Addendum # 1

Bid Opportunity: 26-7883-RFT - Elgin Street Public School Boiler Plant and MUA System Upgrade

**ELGIN STREET PUBLIC SCHOOL
 BOILER PLANT & MUA UPGRADE**

SCALE: QAS NOTED	DRAWN: JC	CHECKED: JC
LON-26001120-A0 EXP PROJECT #	DATE: JUNE 18, 2026	SK# A-1

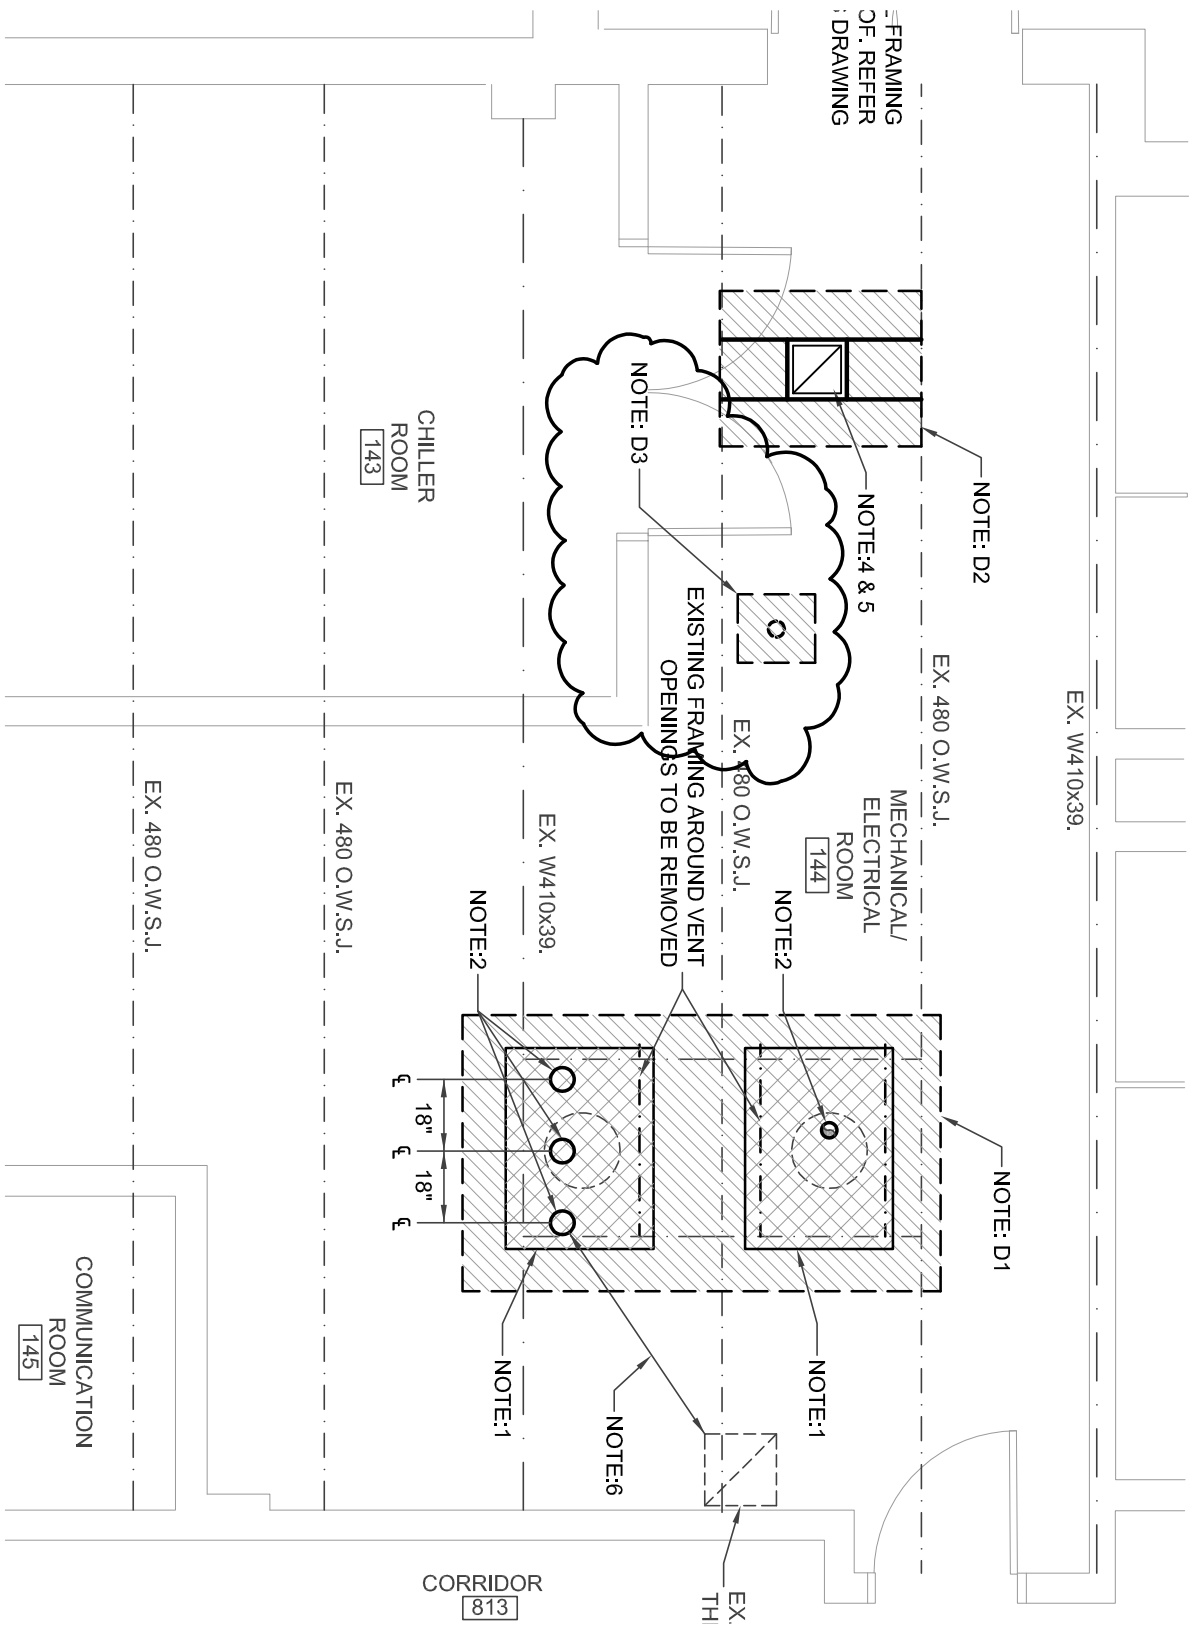
Refer to Drawing A100 AND Sketch SK#A-1

- .1 Contractor to remove enough of existing roof membrane and roof insulation to allow the removal of the existing abandoned water heater venting and to provide enough space to install new steel section of deck at existing opening. (Demolition Note:3D)
- .2 install new section of roof deck as indicated on drawings in Note: 1.

SCALE: QAS NOTED	DRAWN: JC	CHECKED: JC
LON-26001120-A0 EXP PROJECT #	DATE: JUNE 18, 2026	SK# M-1

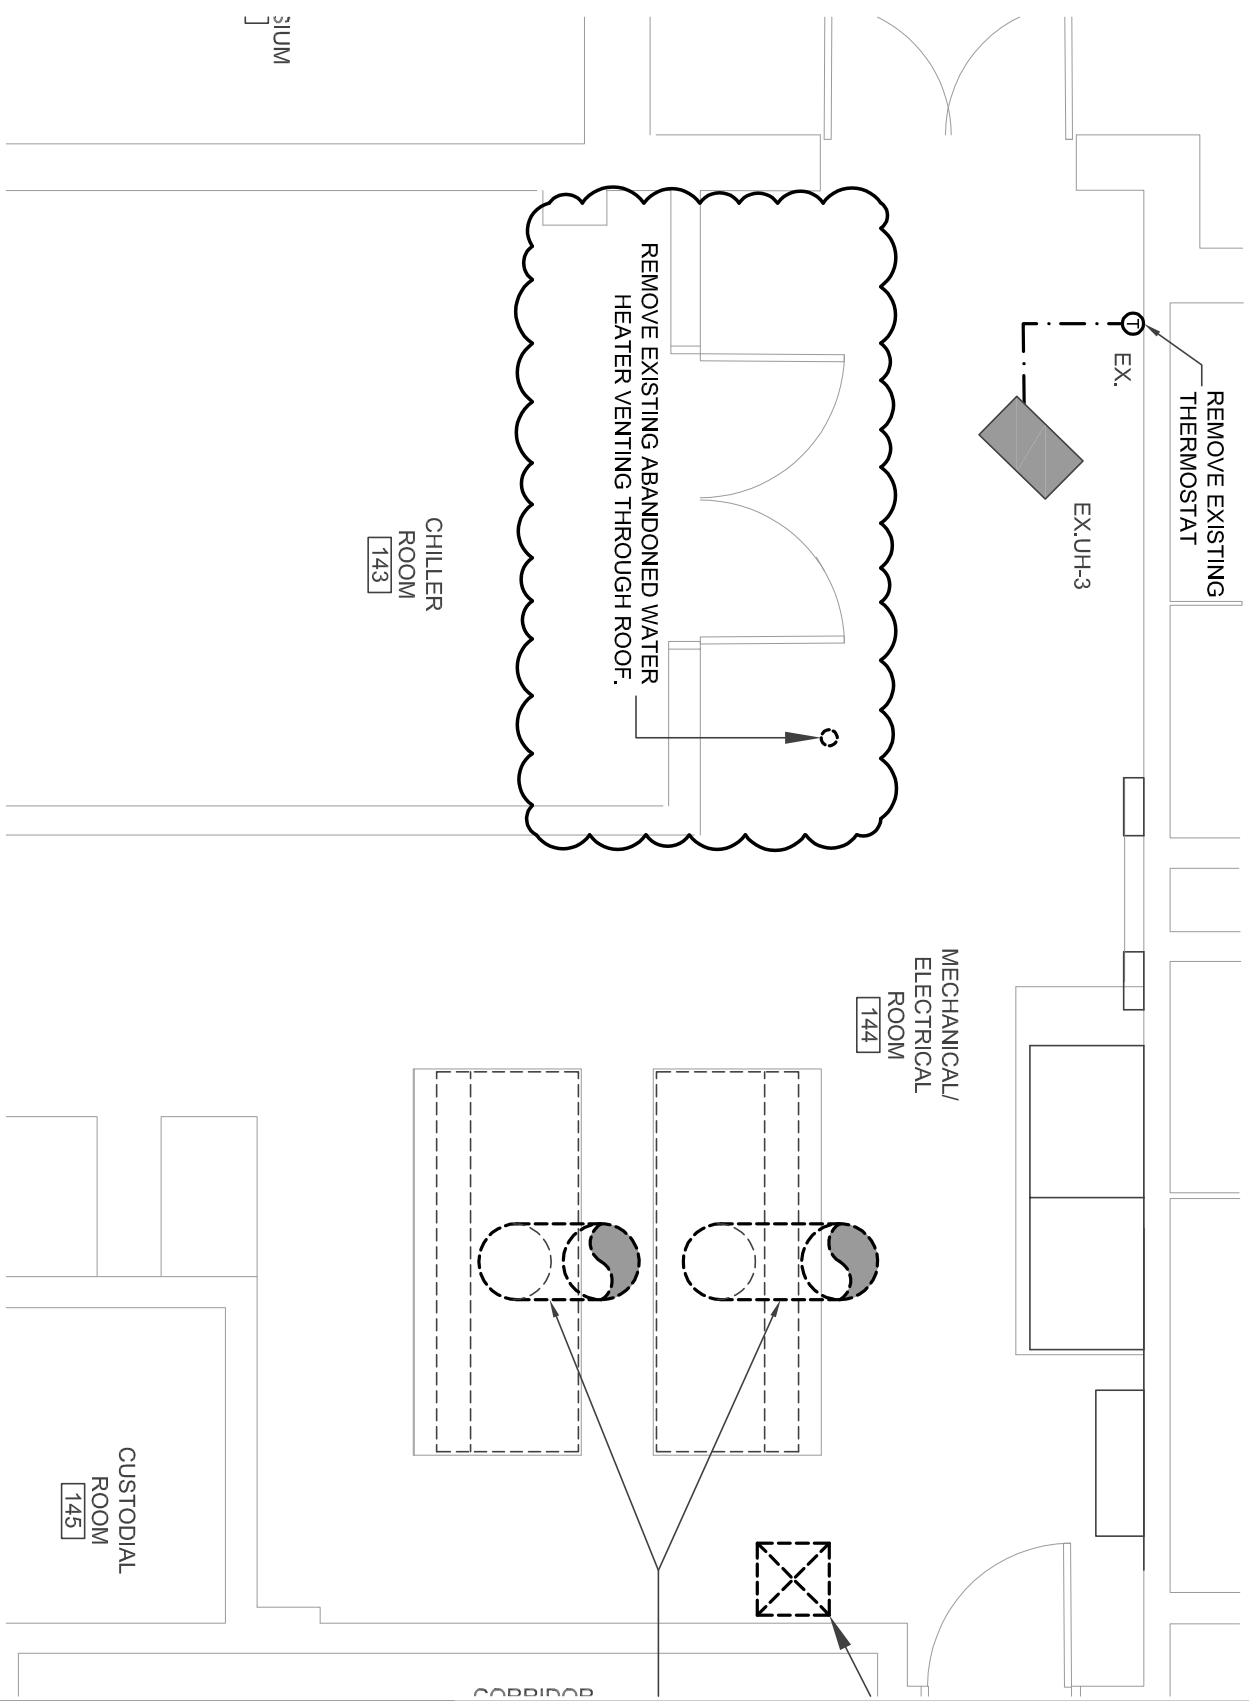
Refer to Drawing M200 & Sketch SK#M-1

- .1 Remove existing abandoned vent from old water heater through roof.
- .2 If Mechanical Contractor uses alternate boiler, they shall provide direct combustion air piping through roof to inlet of boiler. Combustion air piping to be of material and installed as per alternate manufactures' recommendations.
- .3 If Mechanical Contractor use alternate boiler with direct combustion air connections, then the 18"x6" combustion air ductwork shall be removed and a motorized damper installed in the existing 18"x18" duct opening at the roof. Damper to be interlocked with SF-1 & MD-4 to open when SF-1 is energized.
